IEEE 802.16 Broadband Wireless Access Working Group <<http://ieee802.org/16>>

Title **On the use of postamble for the relay link**

Date Submitted **2007-01-18**

Abstract This contribution proposes the use of postamble for the relay link.

Figure xx Example of minimum configuration for an in-band non-transparent frame structure

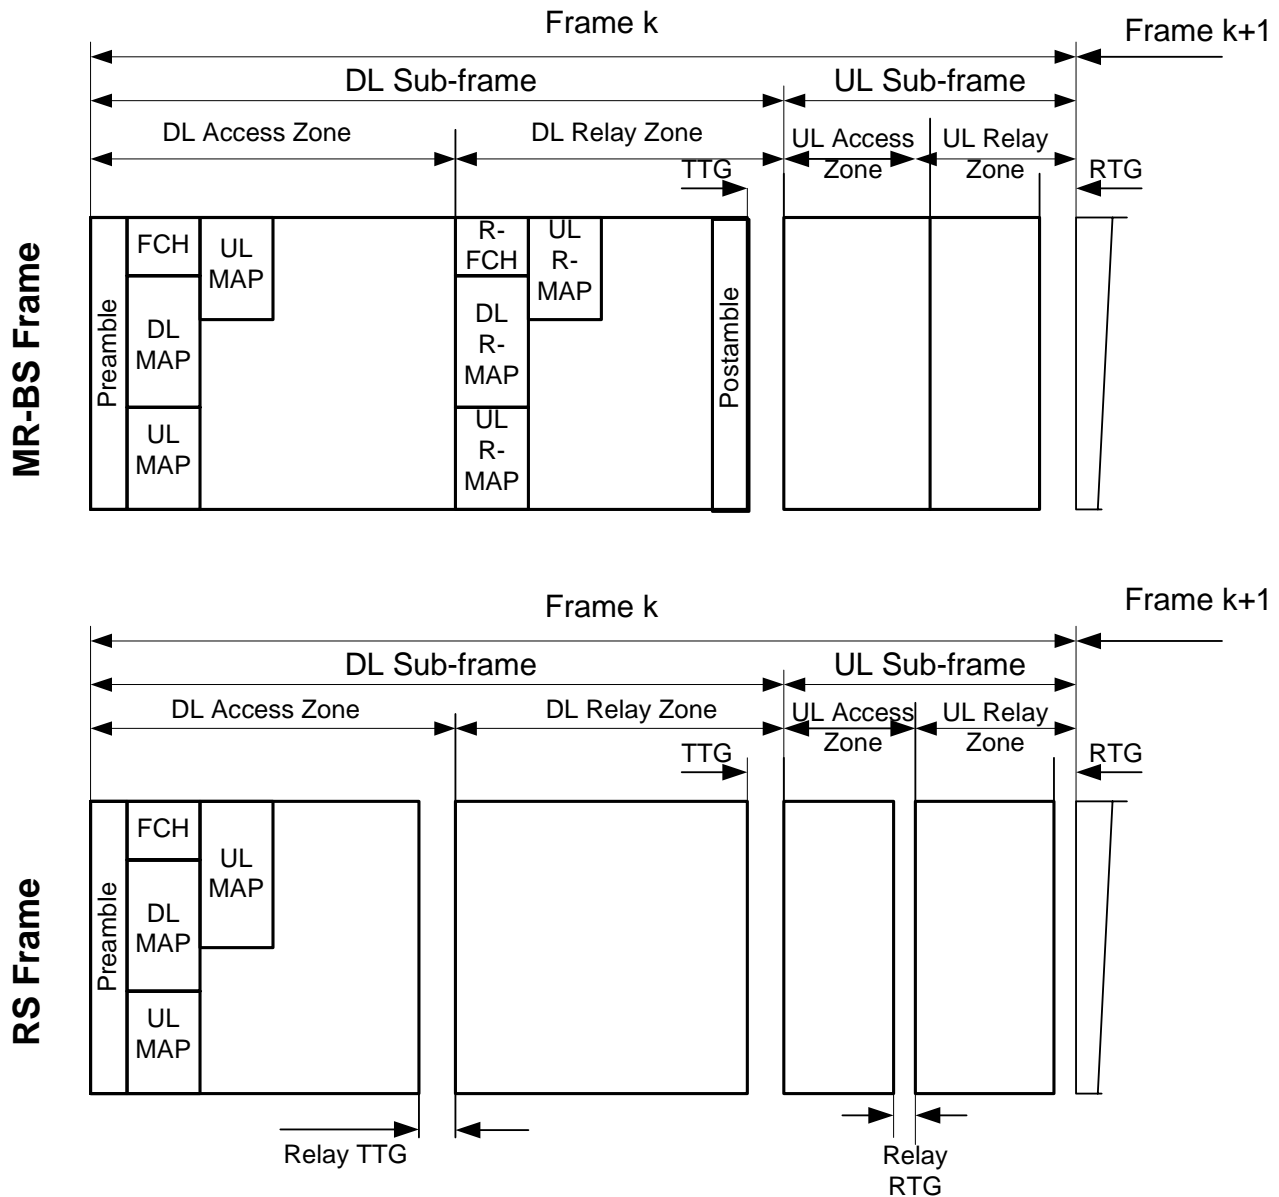
[Replace the Figure xx at subclause 8.4.4.7.2.1:]

The relay link amble, when present, shall be located at the end of the relay zone.
